**UNITED STATES
NUCLEAR REGULATORY COMMISSION**
WASHINGTON, D.C. 20555-0001

**SUBJECT: INDIAN POINT NUCLEAR GENERATING UNIT NOS. 2 AND 3 – SAFETY
EVALUATION REGARDING IMPLEMENTATION OF MITIGATING
STRATEGIES AND RELIABLE SPENT FUEL POOL INSTRUMENTATION
RELATED TO ORDERS EA-12-049 AND EA-12-051 (CAC NOS. MF0737,
MF0738, MF0744 AND MF0745)**

Enclosure:
Safety Evaluation

Figure 1: Unit 2 SFP Elevation View with Levels Indicated

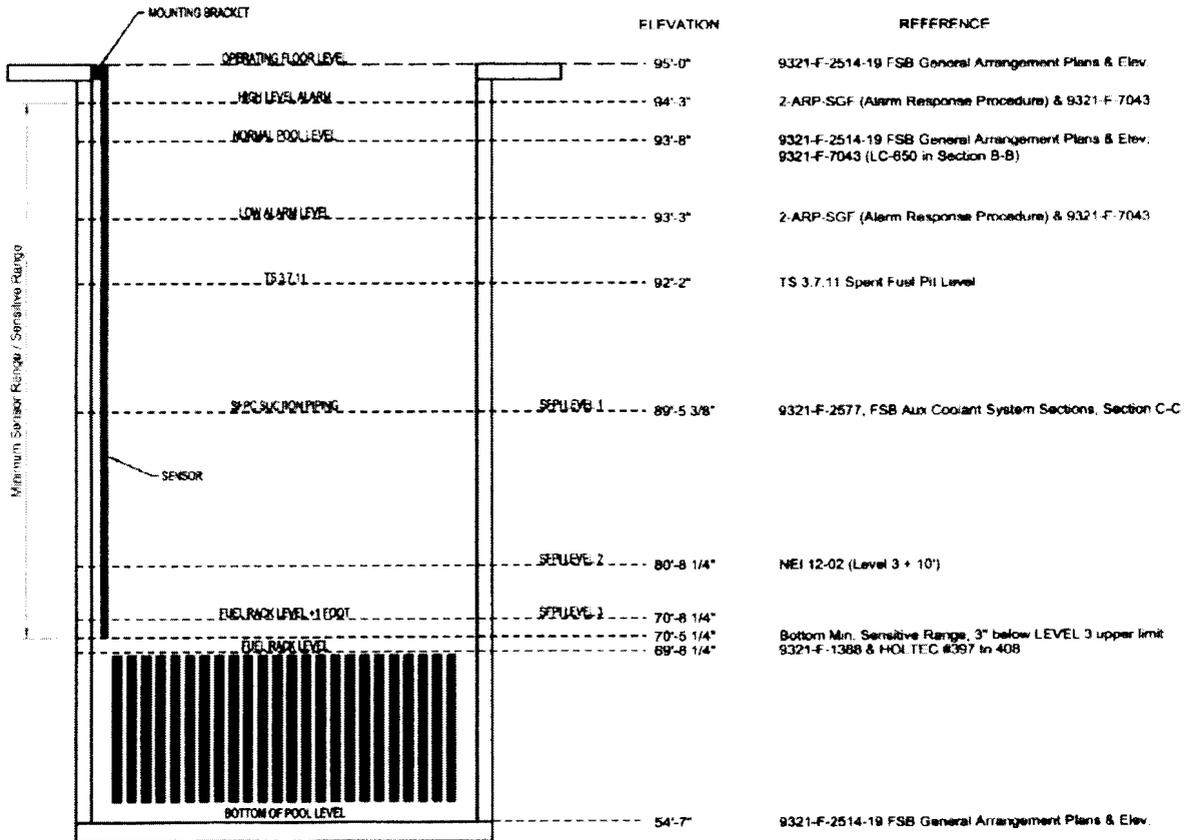
The NRC staff's assessment of the licensee selection of the SFP levels of monitoring is as follows.

In its letter dated February 27, 2015 [Reference 31], the licensee provided figures (Figures 1 and 2 in this SE) depicting the Unit 2 SFP sensor's measurement range from 70 feet, 5¼ inches to 94 feet, 3 inches plant elevation and Unit 3 SFP sensor's measurement range from 70 feet, 4½ inches to 94 feet, 2 inches plant elevation. The NRC staff noted that these measurement ranges cover Levels 1, 2, and 3 as described in Section 4.1 above.
